**Southern
Water**

Our ref
PLAN-028651

Proposal: Single storey rear extension.

Site: AL/53/19/HH:- 32, St Richards Road, Westergate, PO20 3RD.

ARUN DISTRICT COUNCIL AD5319/H

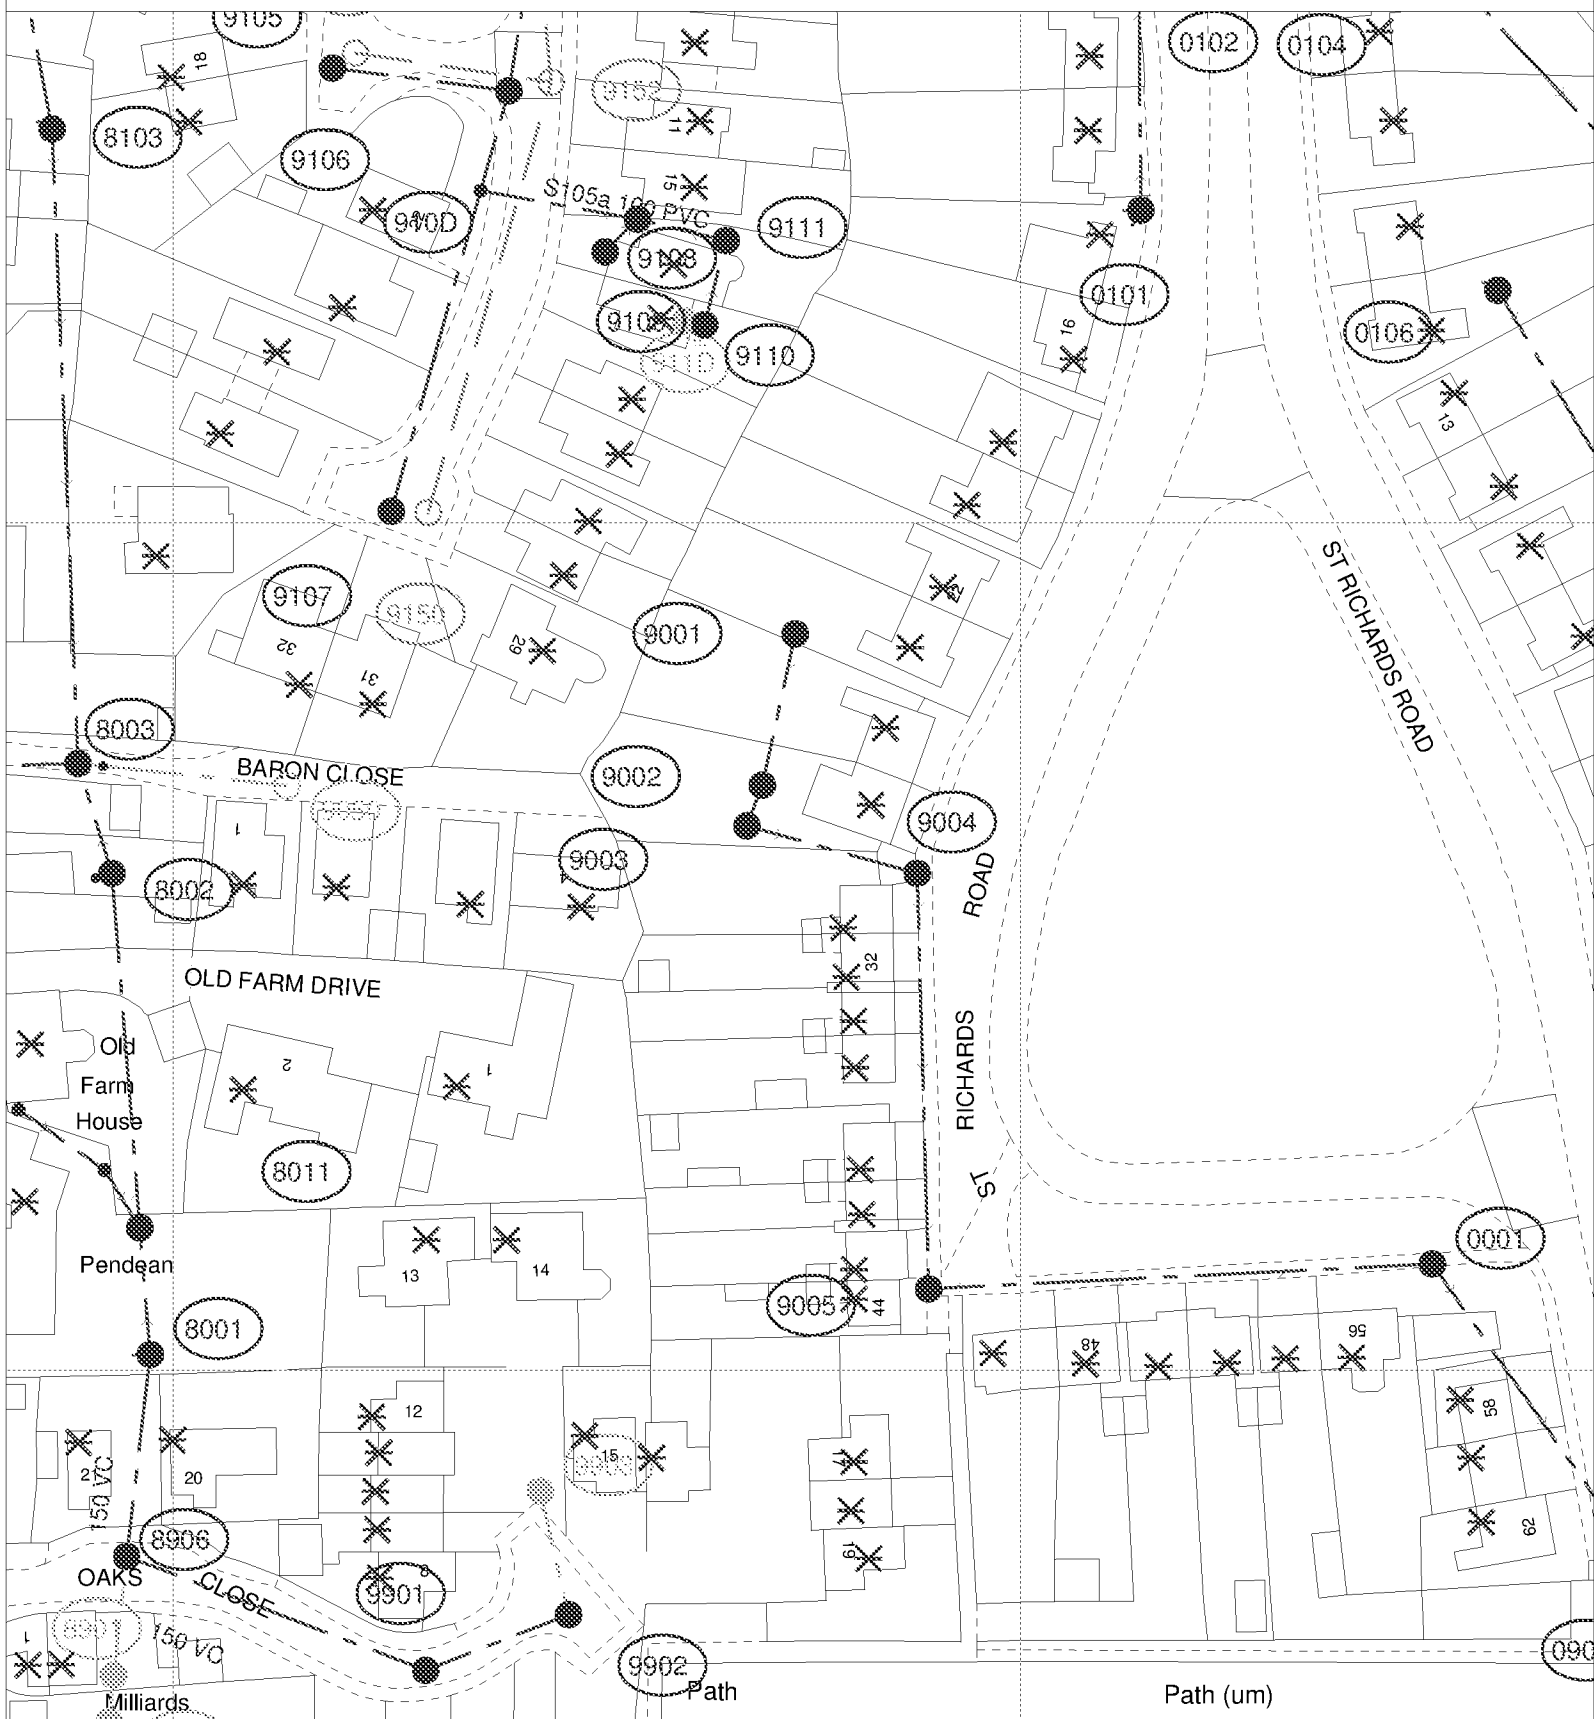
Submitted plan shows the proposed extension lies over an existing sewer serving neighboring property and crossing the proposed site (not shown on our records). An investigation of the sewer is required to ascertain its condition.

Building over a "public sewer" is not normally permitted by Southern Water. However, under certain circumstances building over a sewer may be allowed. The conditions associated with the buildover to a sewer are contained in Southern Water guidance notes which are available at: www.southernwater.co.uk. A formal application to build over to the sewer will required to be submitted by the applicant.

Please find attached a plan of the sewer records showing the approximate position of a public foul sewer in the vicinity of the site. The exact position of the public sewers must be determined on site by the applicant before the layout of the proposed development is finalised.

- No development or new tree planting should be located within 3 metres either side of the external edge of the public sewer.
- No new soakaways should be located within 5m of a public sewer.
- All existing infrastructure should be protected during the course of construction works.
